**Correspondence Between
Staff and Applicant
Approval Letter**

REPORT TITLE: District at the Quarter Traffic Impact Mitigation Analysis

CASE #: 8-ZN-2016

Re: District at the Quarter: 2nd Review Comment Responses and Requested Materials.
Case #: 3-GP-2016 & 8-ZN-2016:
Location: Northeast Corner of Greenway-Hayden Loop & 73rd Street

Attachment 2

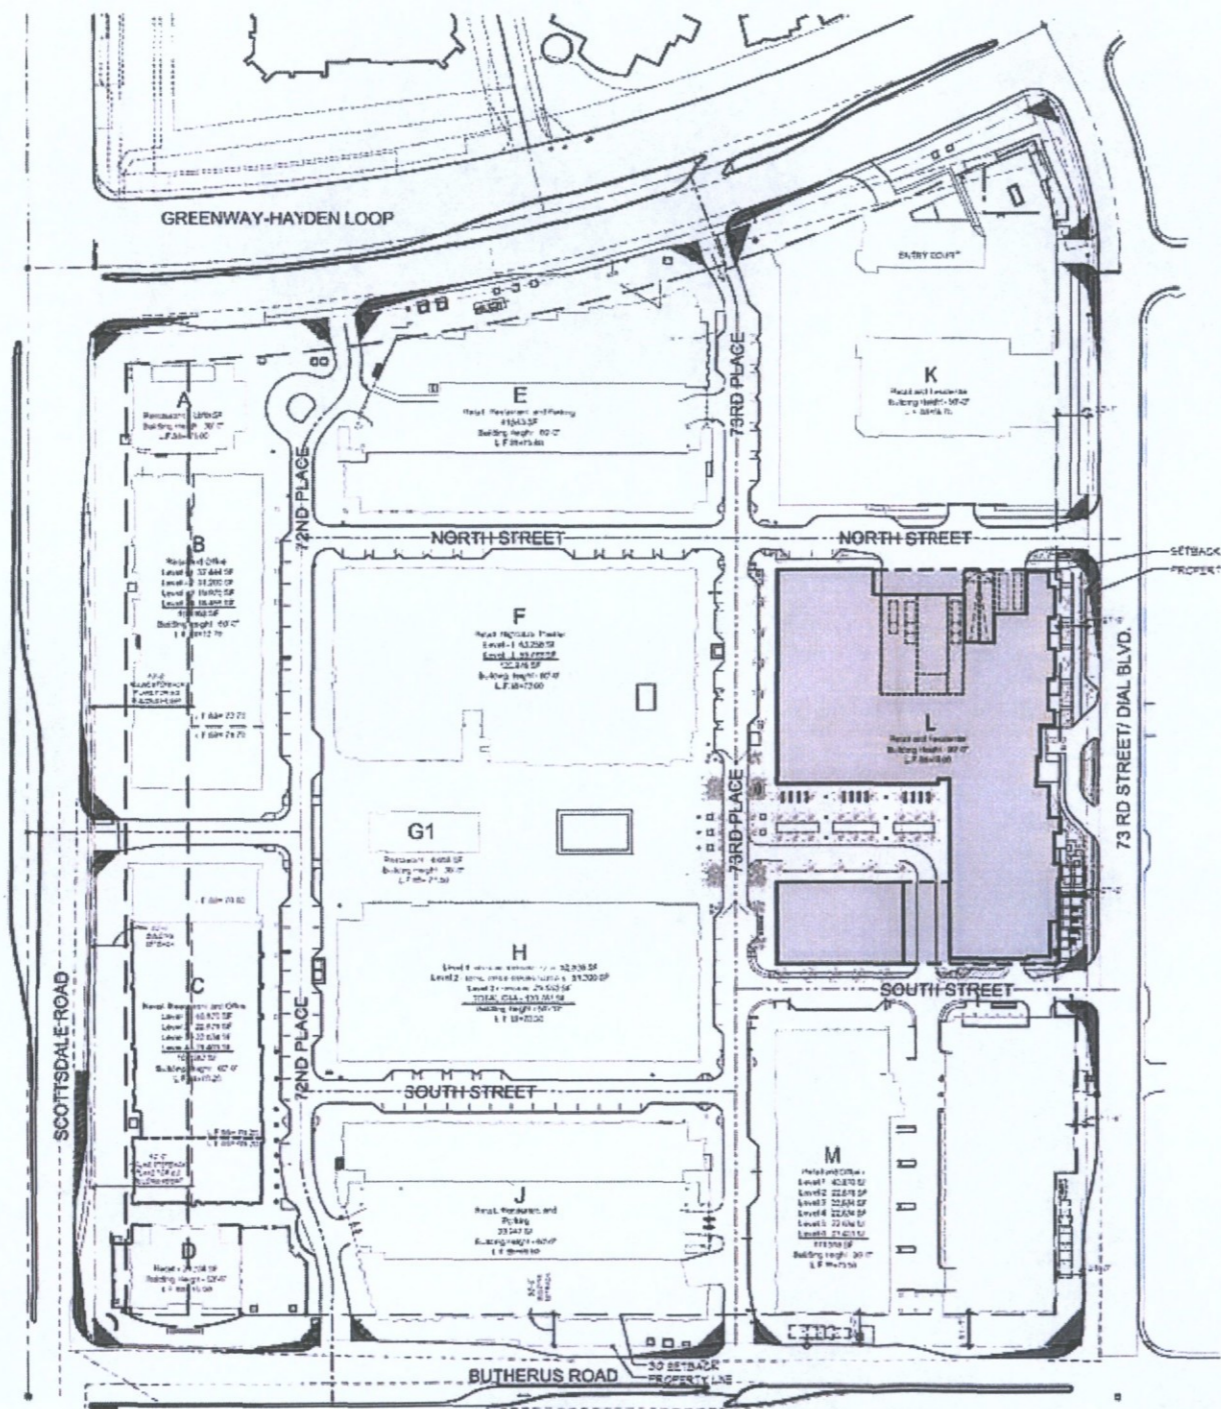
1. Please provide a site plan that complies with the Plan & Report Requirements for Development Applications. There will be comments regarding the site plan after it has been received and reviewed by staff. Please refer to Zoning Ordinance Section 1.303.
